QUALITY ASSURANCE -- NON-CONFORMANCE REPORT

Location: Changxing Island, Shanghai, P.R. China**Report No:** NCR-000624**Prime Contractor:** American Bridge/Fluor Enterprises, a JV**Date:** 11-Jan-2010**Submitting Contractor:** Zhenhua Port Machinery Company, Ltd (ZPMC), Changxing Island**NCR #:** ZPMC-0597**Type of problem:**

Reference Description: Class "A" UT indication discovered after ZPMC NDT testing and acceptance on Segment 5BE/5CE deck transverse weld

Job Name: SAS Superstructure
Document No: 05.03.06-000587

Lift / Segment No.: 5BE/5CE | Location: C4 & C5 R1 | Report Number: UT-5E-015R1

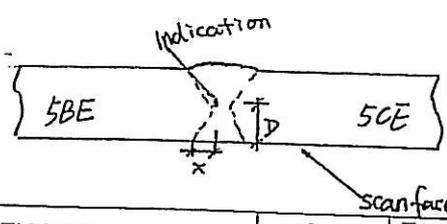
1. The excavation was not in the correct location, relative to the "x" value..
之前没有碳刨到正确的位置, 主要是 "x" 方向有误。
2. Inter pass cleaning may not have been adequate for all SMAW passes, very small defects as indicated in the UT report db readings.
对于SMAW焊道间的清理可能不到位, 通过UT报告来看, 其中有许多很小的缺陷。

Weld No.	Indication No.	Scan Face	Dimensions (mm)				Indication Rating "d"	Evaluation	Inspector	Inspection Date
			"Y" from O Axis	"X"	Length "L"	Depth "D"				
OBESA-009-1 (C5)	1	Outside	2110	15	6	7.83	+17	TLI-REJ	S021	2010.1.15
	2		2120	15	8	7.8	+17			
	3		3428	15	5	12	+14			
	4		3438	15	8	9.9	+15		S004	
	5		3448	15	5	13.1	+17

ABF assist to lay out repair area prior performing repairs. Notify CT prior to laying out/performing repairs.

Lift / Segment No.: 5BE/5CE Location: A1. A2 RI Report Number: UT-5E-011R1

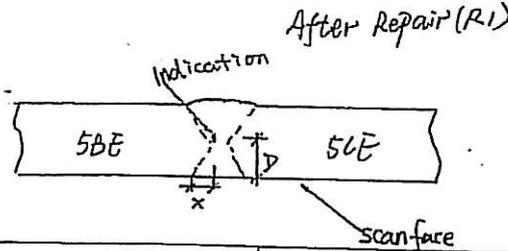
- One (1) longitudinal class "A" linear indication measuring approximately 15mm in length.
- The weld is identified as OBE5-008.
- The indication dBs rating is a +4.
- Y-location is 9360mm from the Crossbeam Side (Working point W5).
- Material thickness is 14mm.
- The depth of the indication is approximately 10mm.
- The indication is clearly marked on or near the weld.
- The weld is a Complete Joint Penetration (CJP) butt weld joining deck panels of segment 5BE to 5CE transverse splice.
- Segment 5BE/5CE is located in Trial Assembly area.

Weld No.	Indication No.	Scan Face	Dimensions (mm)				Indication Rating "d"	Evaluation	Inspector	Inspection Date
			"y" from O Axis	"x"	Length "L"	Depth "D"				
0BE5-008 (A1RI)	/	outside	/	/	/	/	ACC	S013	2010.1.10	
0BE5-009 (A2RI)	/	outside	/	/	/	/	ACC	S016	2010.1.10	
0BE5-008	1	outside	9360	10	15	10.5	4	CLASS A REJ	CT	11 JAN 10
ADDITIONAL CT FINDINGS 11 JAN 10

Repair indication and perform required NDT.

Contractor submitted CWR and NDT documentation verifying the repair has been made and the weld is in conformance with Contract specifications.
